**RE: Issues for IPC hearing for Kariong Sand and Soil Supplies - Air Quality**

Todoroski Air Sciences (TAS) has previously reviewed the *Kariong Sand and Soil Supplies Air Quality Assessment – RTS* prepared by Northstar Air Quality (dated 10 December 2020) on behalf of five nearby landowners of Acacia Road and Debenham Road, Somersby (Lot 3 239 Debenham Rd East, Somersby, 252 Debenham Rd East, Somersby, 242 Debenham Rd East, Somersby, 10 Acacia Rd, Somersby, 12 Acacia Rd, Somersby).

Figure 1: AERMET meteorological data used in the model (left) vs. TAS anticipated nearby data (right)

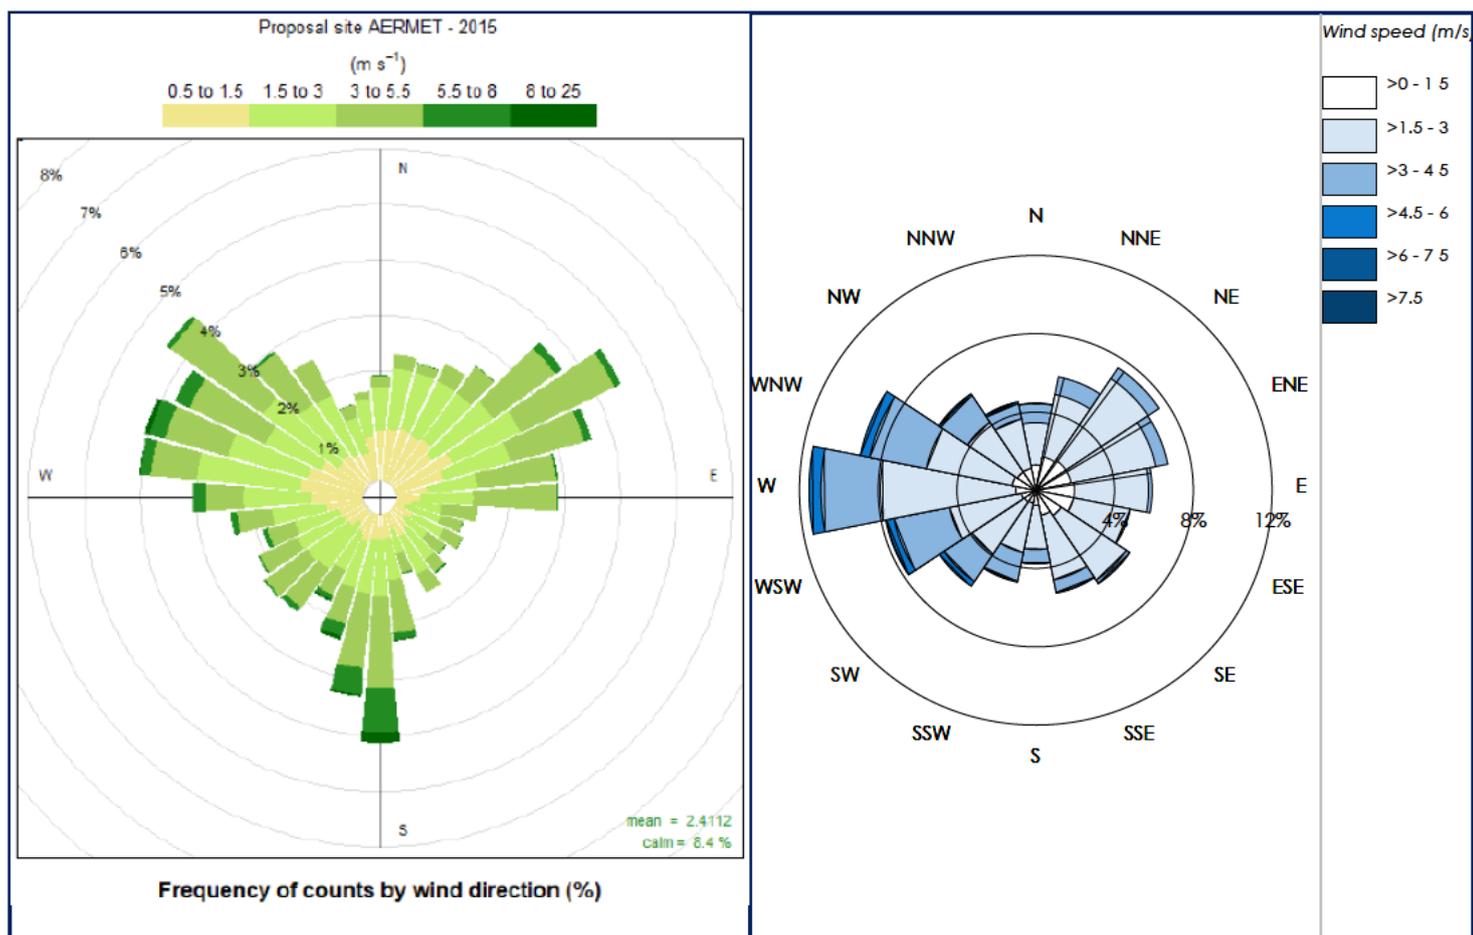
A comparison of the NorthStar meteorology used in the modelling and my own meteorology derived for a location nearby is set out in the figure below. The NorthStar windrose on the left uses 36 x 10 degree segments, and the TAS wind rose on the right uses the standard compass directions (16 x 22.5 degree segments).

It is significant that the figure shows the NorthStar data used in the modelling does not contain the predominant strong westerly winds reported by the residents modelling data but these winds do arise in the TAS wind rose. The NorthStar data shows approximately 4-5% of its westerly winds are above 3m/s, compared to approximately 14% in the TAS wind rose. This shows that the westerly winds of most relevance for assessing the impacts are underestimated by a factor of approximately three fold in terms of their frequency of occurrence. The modelling would thus significantly underestimate the frequency and amount of dust blowing towards residents due to wind erosion from the open stockpiles and open roads, and open material transport and handling areas.

Overall, the NorthStar modelled data underestimates the frequency of the most critically relevant winds from the west, both the high and low wind speeds.

We see unrealistic southerly winds (both frequency and speed) in the NorthStar modelling (caused by high-speed winds blowing across open water towards the Gosford site), and we do not hear this from the residents or see it in my modelling. Similarly, the Northstar modelling over-represents the northwest and northeast winds (as caused by winds funnelling around the prominent ridge north of the Gosford stations), yet, again, such winds are not reported by residents, nor do they appear in my modelling.

In the Northstar modelling, we also see almost nil wind speeds above 5.5 m/s from the south east, but more winds between 3 and 5.5 m/s from this direction. Wind erosion tends to start at wind speeds above 5.4 m/s, and air dispersion improves when wind speeds are above 3m/s, and so this will tend to underestimate the impacts from the existing quarry (there is more discussion about this later).
